AGENDA

La Vergne Planning Commission
September 30, 2025 at 6:00 PM

Item #: 4. Site Plan – Restaurant and Retail Building at 192 & 198 Old Nashville Highway – Existing and Proposed Buildings of 15,521 Square Feet on 1.35 Acres. Requested by Huddleston Steele. Property located at 192 & 198 Old Nashville Highway (Tax Map 15M, Group E, Parcels 4 & 5). C-2 (Highway Service) Zoning District. Property owned by Better Home, LLC.

SHEET NO. C6.03

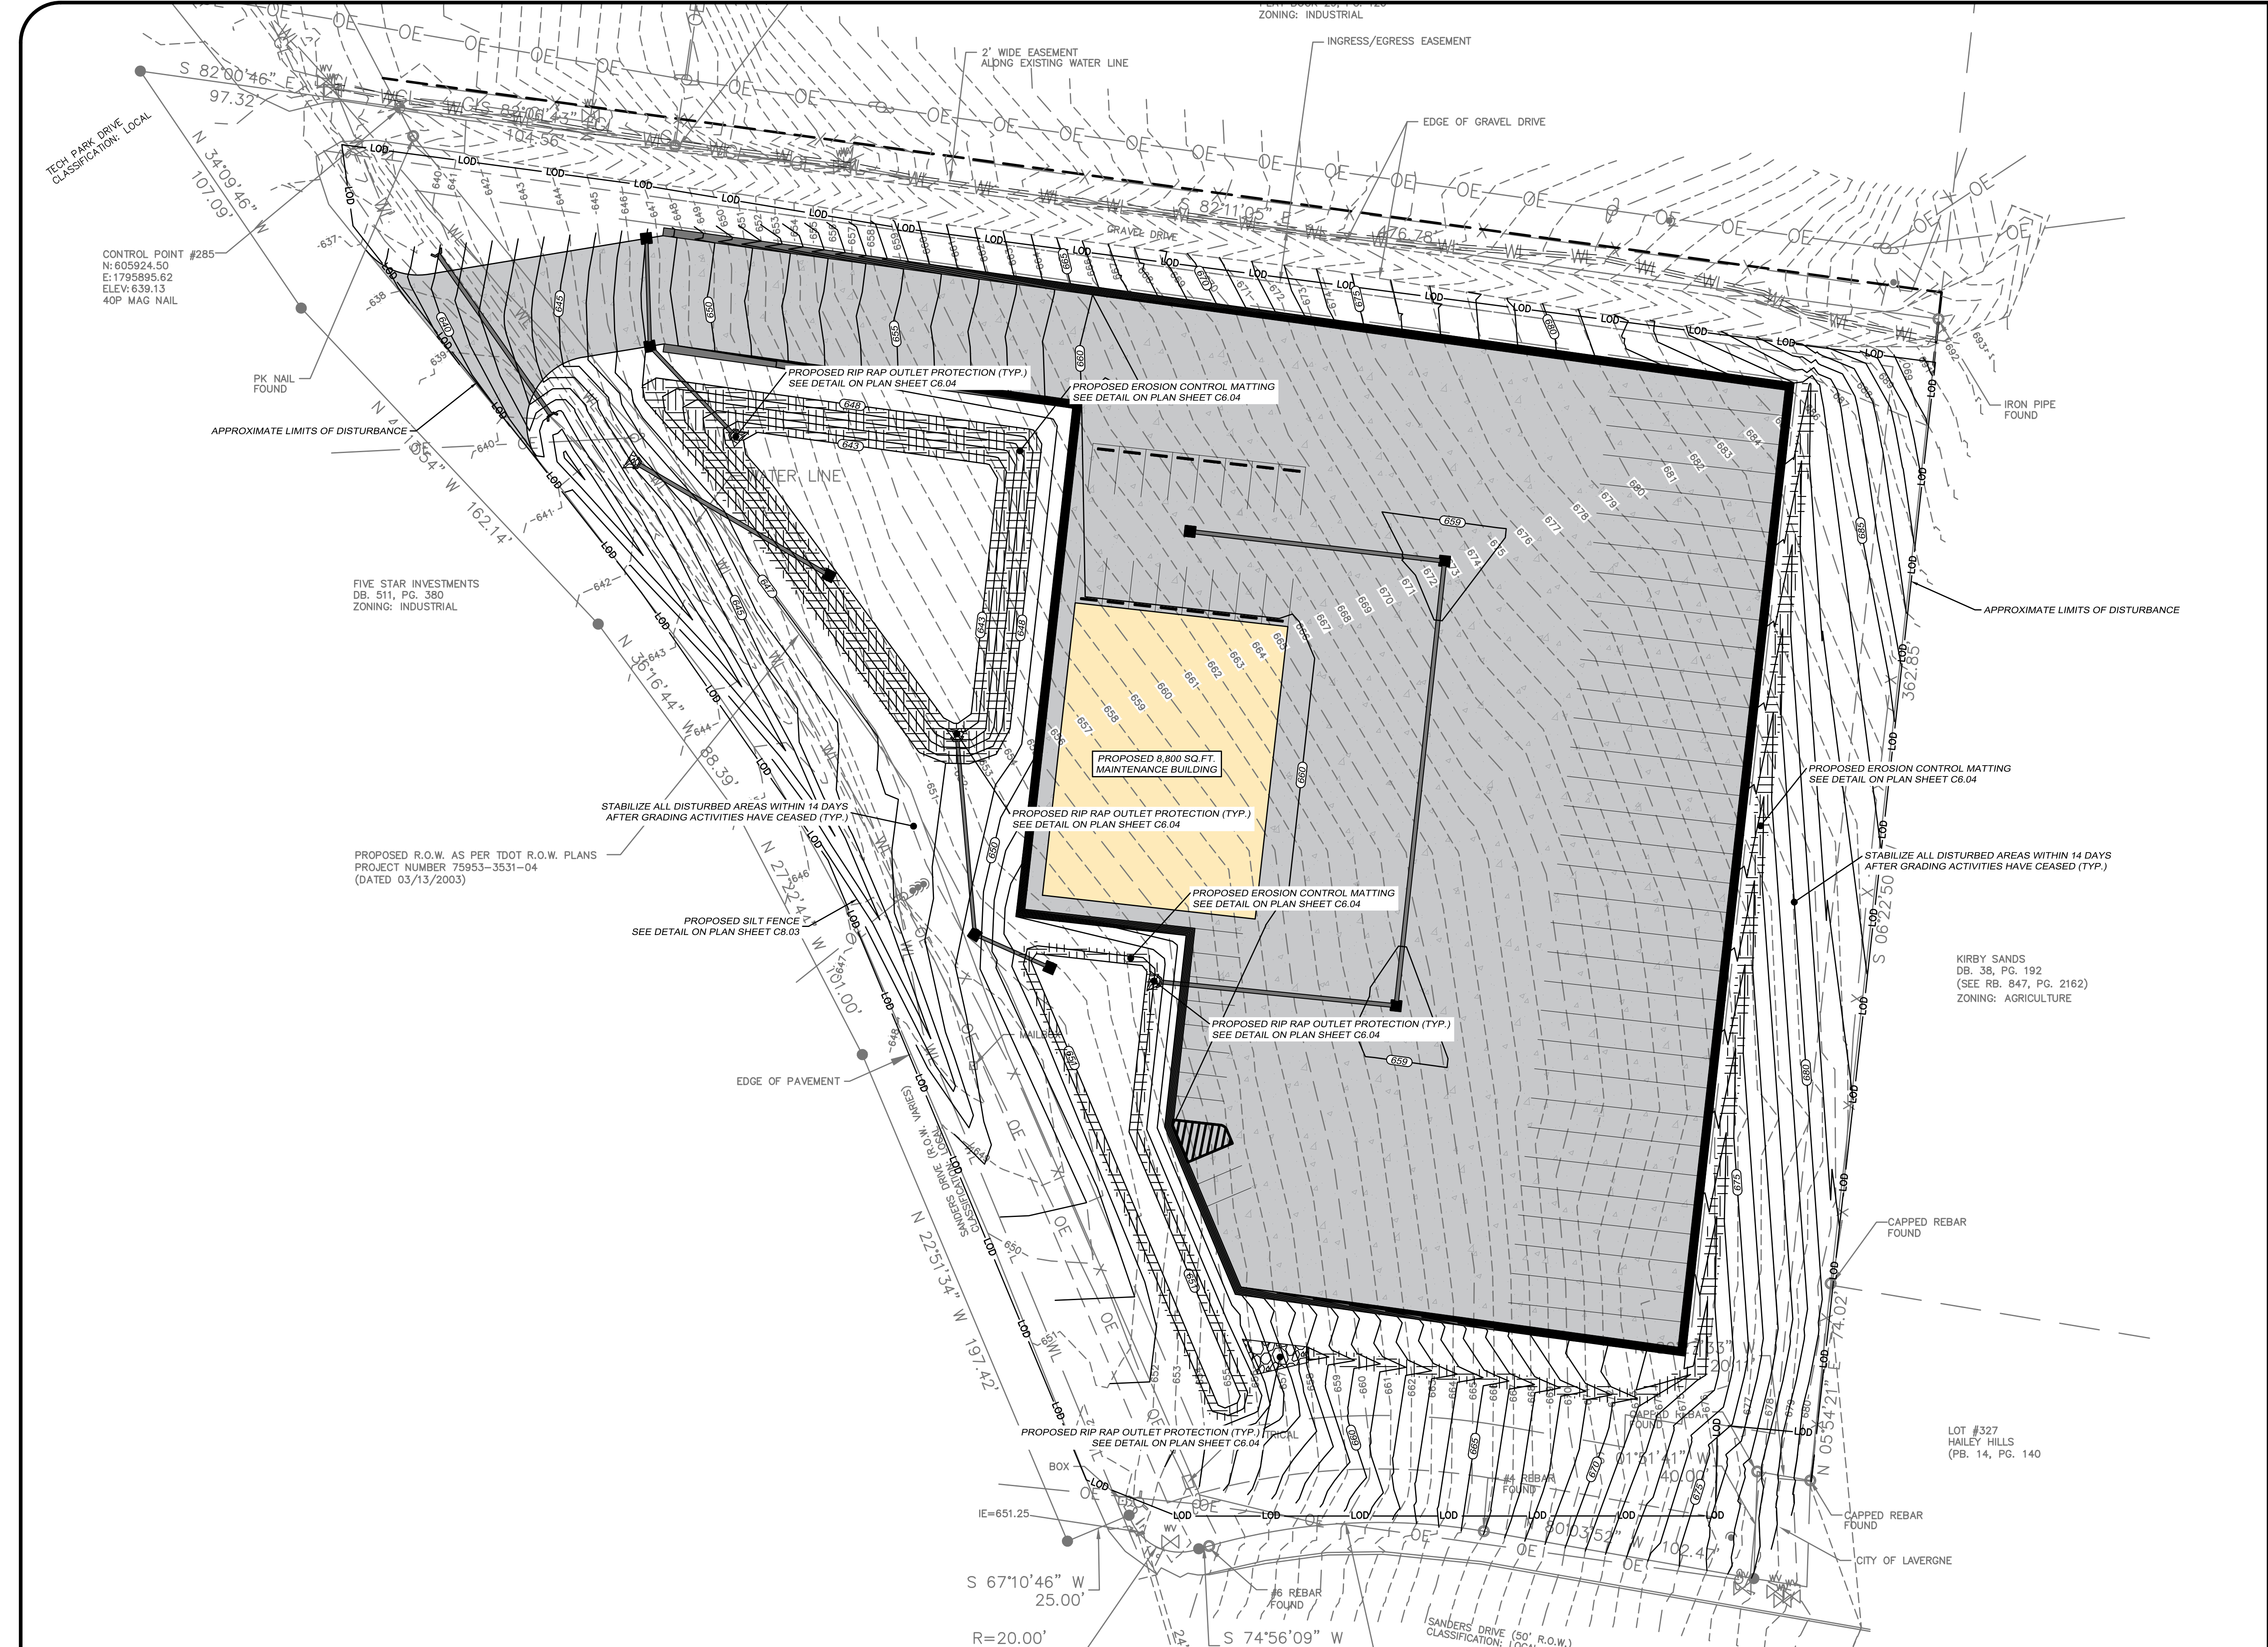
21. (Sheet C4.01) Provide erosion protection from the outfall of Storm Line D down to the flowline of Ditch A.
22. (Sheet C6.03) Provide a note that all EPSC controls shown on this sheet are permanent.

41. (Sheet C6.03) Change notes to "Final" notes.
42. (Sheet C6.04) Provide as detail for riprap outlet protection which includes geotextile, D50, of riprap installation, and minimum area.

SHEET NO. C6.04

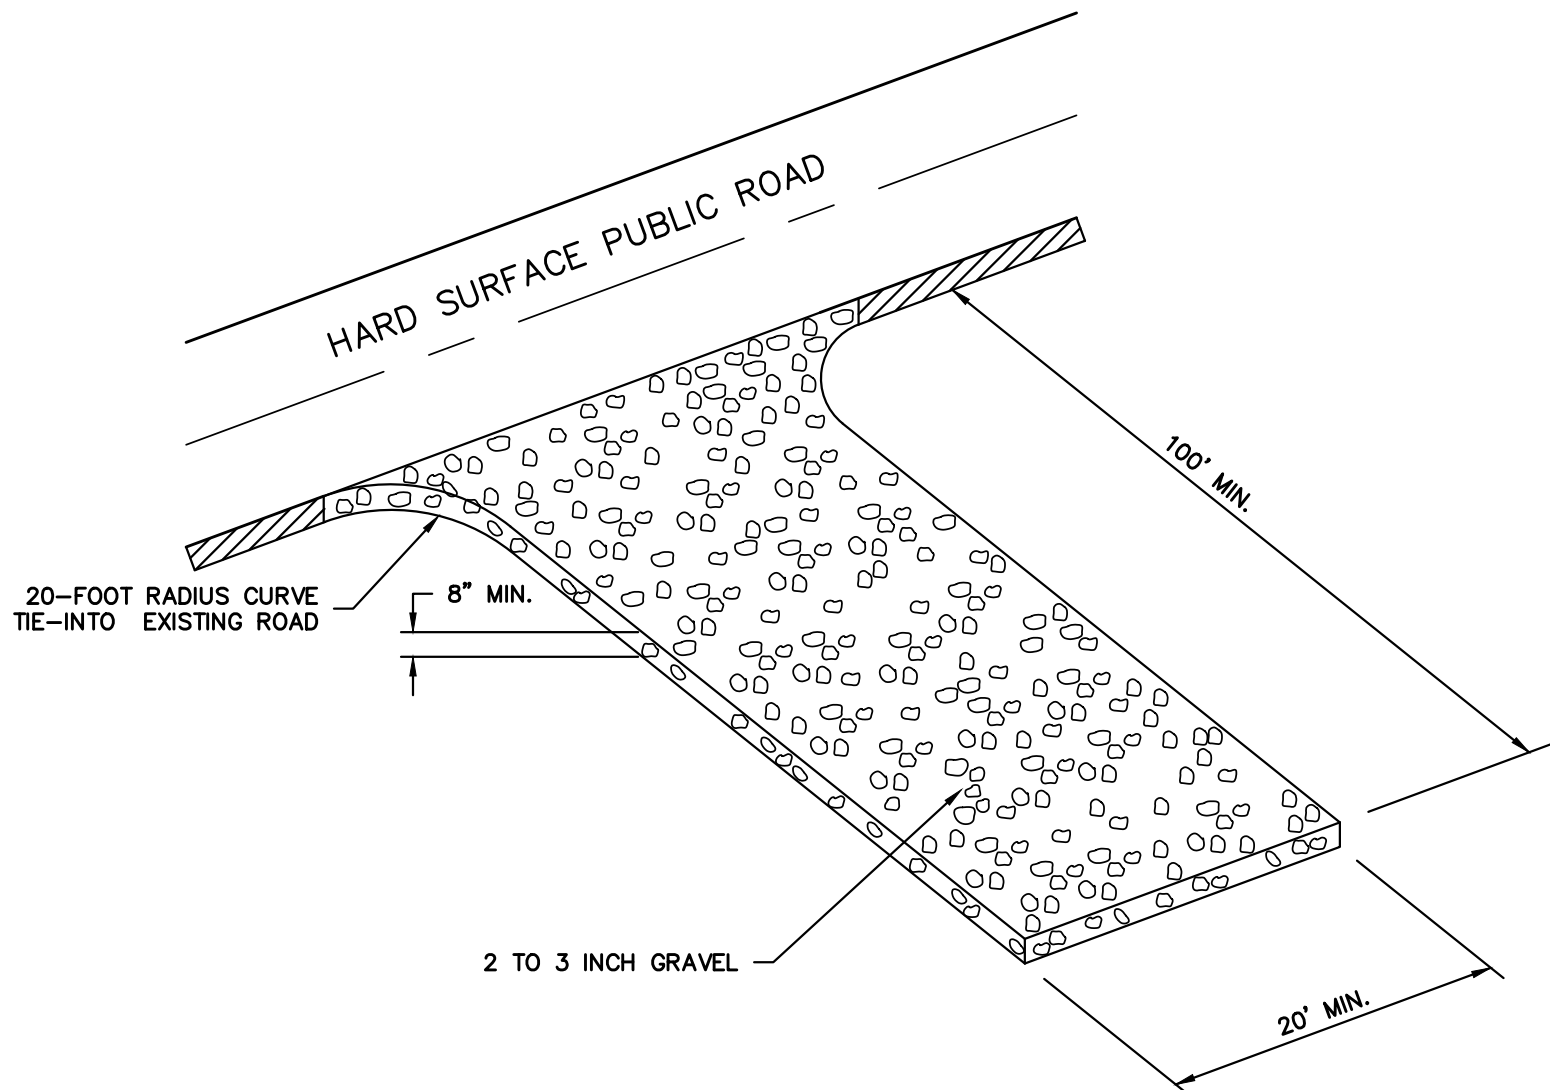
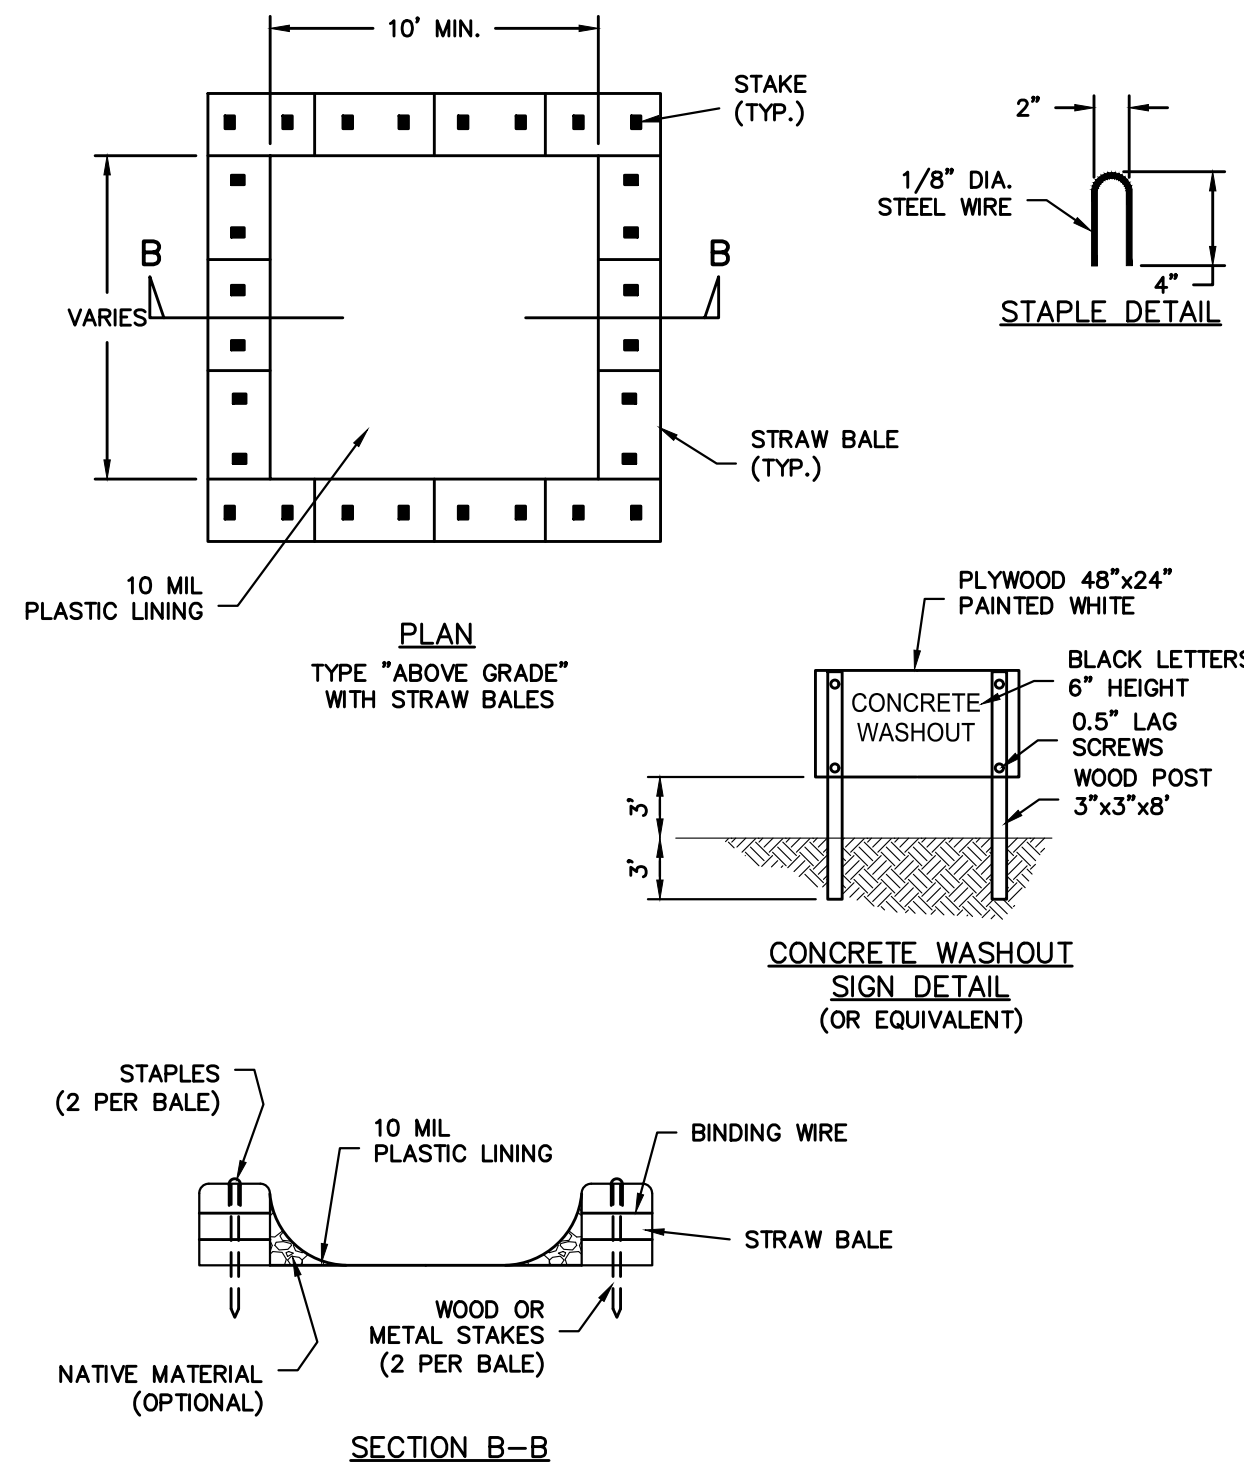
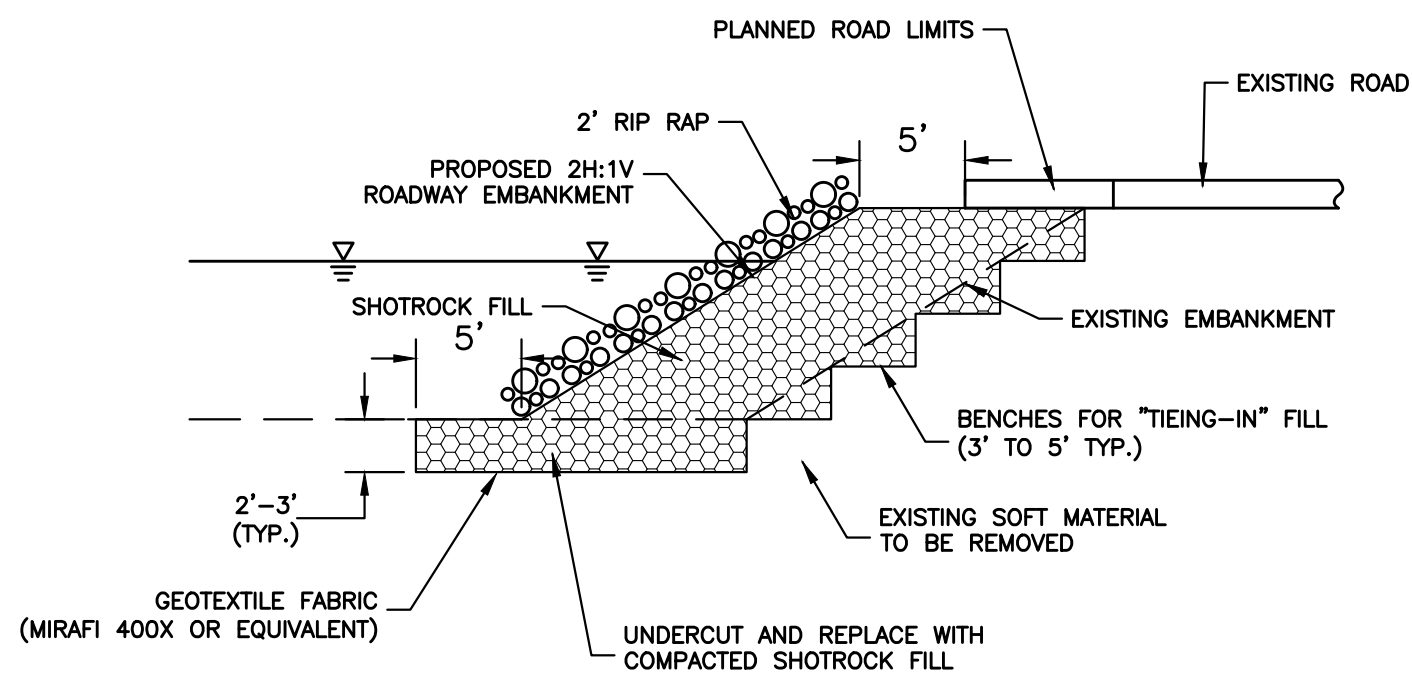
36. (Sheet C6.04) Slope Stabilization Detail references stations that were not found on any other plans. It doesn't appear to correlate with these plans. Modify detail.
